SERVICE INFORMATION LETTER NO. 0143

1. **SUBJECT:** Inadvertent Trim Motor Operation on 24 Volt D.C. Systems
2. **MODELS:** F-28C, F-28C-2, 280C, F-28F, 280F, and 280FX Helicopters.
3. **EFFECTIVITY:** F-28C, F-28C-2, and 280C: All serial numbers converted to a 24 volt D.C. electrical system.

Figure 1

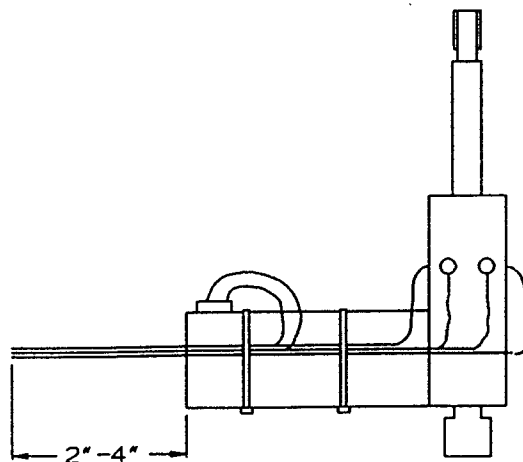
- 5.2.3) Remove both trim actuator assemblies (longitudinal located under the co-pilot's seat and lateral located under the pilot's seat) and rewire per schematic 28-19050, Revision B. NOTE: Use pin housing, P/N 1-480426-0, and pins, P/N 60618-1 and 60620-1, for P17 and P18. The pigtails should be at least two to four inches past the back of the trim motors (See Figure 1). Use pin, P/N 60618-1, in positions 1 & 4 and pin, P/N 60620-1, in positions 2 & 3 of both pin housings. Change the wire markers as follows: 40-14A to 37-35B, 40-14B to 37-34B, 40-13A to 37-32B, 40-13B to 37-33B, 40-15A to 37-36B, 40-15B to 37-37B, 40-16A to 37-39B, 40-16B to 37-38B, and remove the wire markers from the red and black wires for the trim motors.

Figure 2

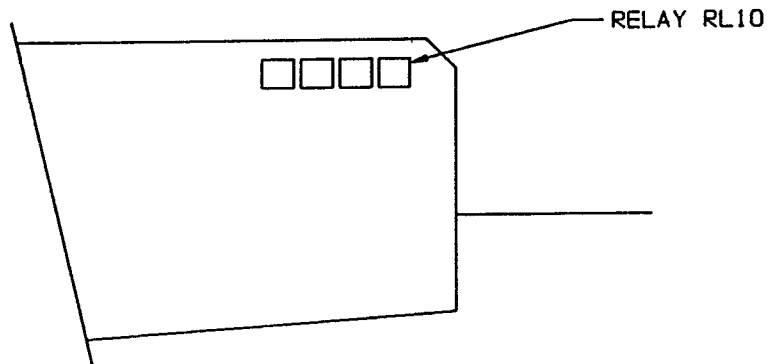
- 5.2.6) Remove all other wires going to the relays at this time. NOTE: Save the wire as you will be reusing some of it later.
- 5.2.7) Remove relays RL7, RL8, RL9, and RL10.
- 5.2.8) Mount TSU1 (trim switch unit 1) by picking up the top mounting hole from where relay RL10 was mounted (See Figure 2). Locate TSU1 on the outside of the seat structure with the unit facing fore and aft (NOTE: Wires point aft). Drill the second mounting hole with a #29 drill.

- 5.2.9) Once the second mounting hole has been drilled, remove TSU1 from the outside of the seat structure and mount on the inside of the seat structure with the wires pointing aft using AN960-10 washers as spacers between the TSU and the seat structure (two places). Secure with AN526-632R6 screws and nuts and washers from the removal of the trim relays.
- 5.2.10) Use two ABMM-AT-C tie rap mounts to route the wire from the TSU so that plug (P16) is located beneath the TSU facing forward.

Figure 3

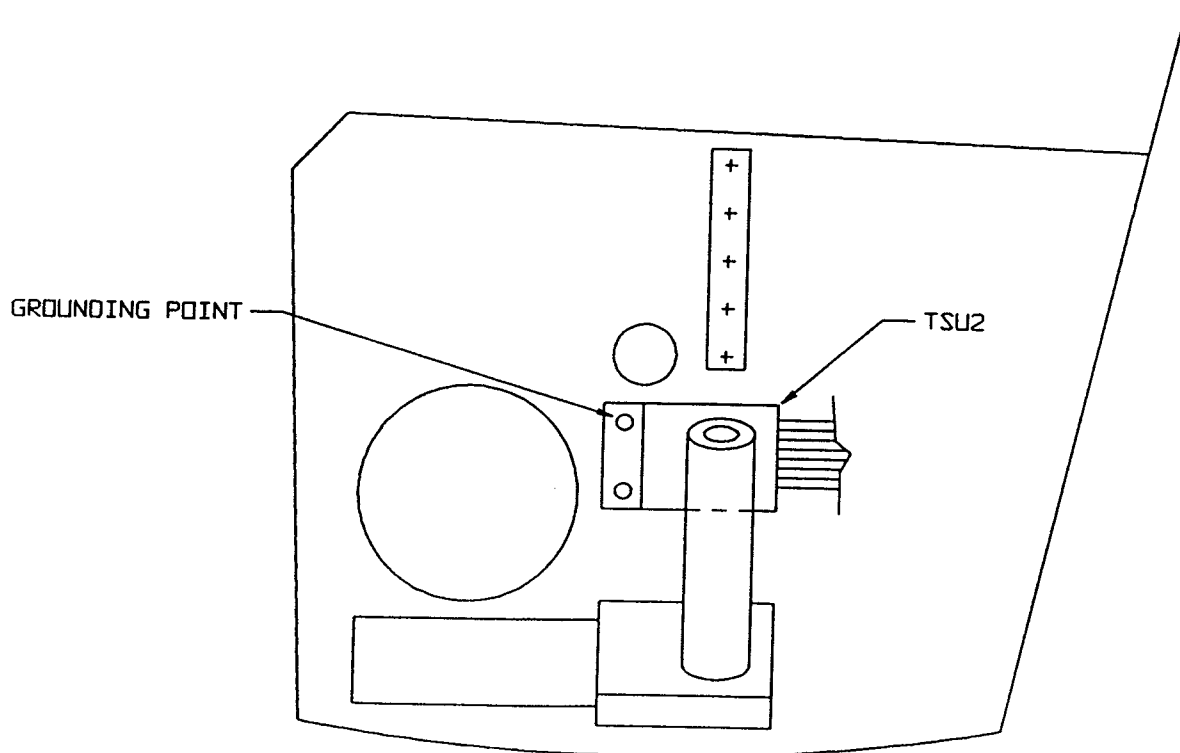
- 5.2.16) Mount TSU2 to the longitudinal beam seat structure on the pilot's side below the pilot's seat with the unit facing fore and aft (NOTE: wires pointing aft) using the hole from old grounding point and upper hole on TSU. Drill lower hole with #29 drill (See Figure 3).

- 5.2.17) Mount TSU2 with AN960-10 washers as spacers (2 places) in the pilot's seat location. Also add ground wire 37-43 to the upper mounting screw. Secure with AN526-632R6 screw in the lower hole and AN526-632R7 screw in the upper hole and nuts and washers from removal of the trim relays. NOTE: Use terminal AA532-06 with wire 37-43 at the ground location.
